# DIFFERING PROFESSIONAL OPINION

1. DPO CASE NUMBER  
DPO-2005-002

SUBJECT: DIFFERING PROFESSIONAL OPINION (DPO) ON RED OIL EVENTS  
AT THE PROPOSED MIXED OXIDE (MOX) FUEL FABRICATION  
FACILITY  
DOCKET NUMBER: 070-03098

**DIFFERING PROFESSIONAL OPINION ON**  
**RED OIL EVENTS AT THE**  
**PROPOSED MIXED OXIDE (MOX) FUEL FABRICATION FACILITY**  
**DOCKET NUMBER: 070-03098**

Figure A: Comparison of the Applicant's Red Oil Safety Strategies with DOE/DNFSB (formerly Open Item CS-01) Recommendations

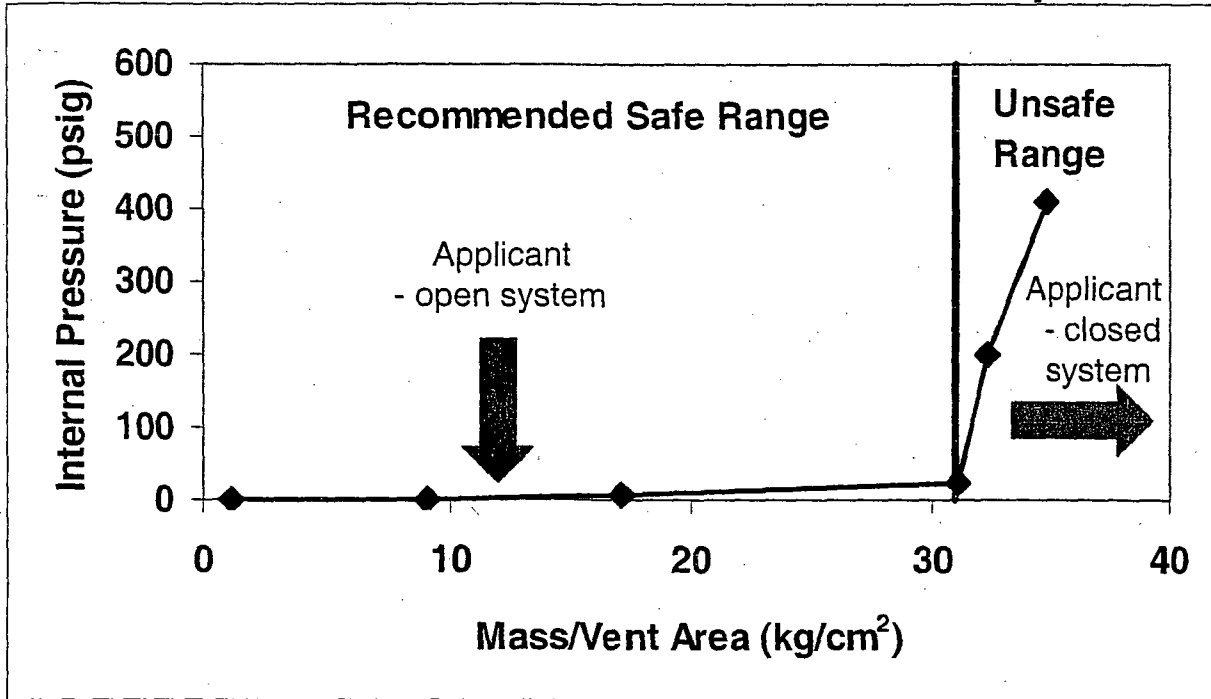
1. Contradictions with DOE/DNFSB RAGAGEP are not explained. In particular, the RAGAGEP shows the applicant's proposal for closed systems being entirely in the unsafe regime (Figure 2).

1. Contradictions with DOE/DNFSB RAGAGEP (Reasonable And Generally Accepted Good Engineering Practice) are not explained. In particular, the RAGAGEP shows the applicant's proposal for closed systems being entirely in the unsafe regime (Figure 2).
2. There is inadequate margin in the design basis temperature.
3. The venting is insufficient to avoid choked flow and pressurization, which has the ability to rapidly raise the temperature even with the applicant's proposed strategy functioning.

Figure 2: Comparison of the Applicant's Red Oil Safety Strategies with DOE/DNFSB (formerly Open Item CS-01) Recommendations

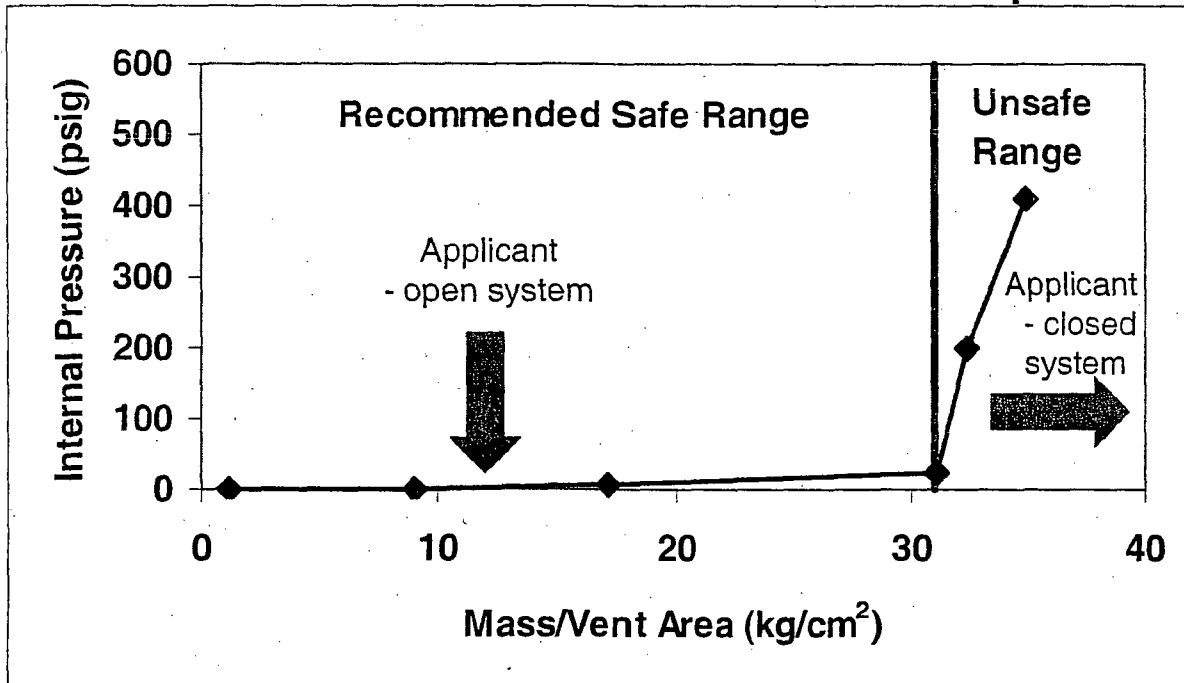
- **Pressure/Venting:** DOE/DNFSB use a pressure/vent relationship (Figure 2) that is well within the safe range identified from experimental testing. The applicant's approach for open systems is also well within the safe range. In contrast, the applicant's approach for closed systems (i.e., evaporative cooling) far exceeds the safe limit and is well into the unsafe range. Common mode failure is likely - reaction products from the red oil reactions cannot escape and provide evaporative cooling, resulting in choked flow, which increases temperature, resulting in suppressed evaporation, which increases temperature, resulting in increased red oil reaction rates etc. - ultimately, this leads to a runaway reaction and explosion. The loss of evaporative cooling effectiveness above 120 C is noted in articles cited in the staff's DSER and RDSER.

1. Contradictions with DOE/DNFSB RAGAGEP are not explained. In particular, the RAGAGEP shows the applicant's proposal for closed systems being entirely in the unsafe regime (Figure 2).
2. There is inadequate margin in the design basis temperature.
3. The venting is insufficient to avoid choked flow and pressurization, which has the ability to rapidly raise the temperature even with the applicant's proposed strategy functioning.
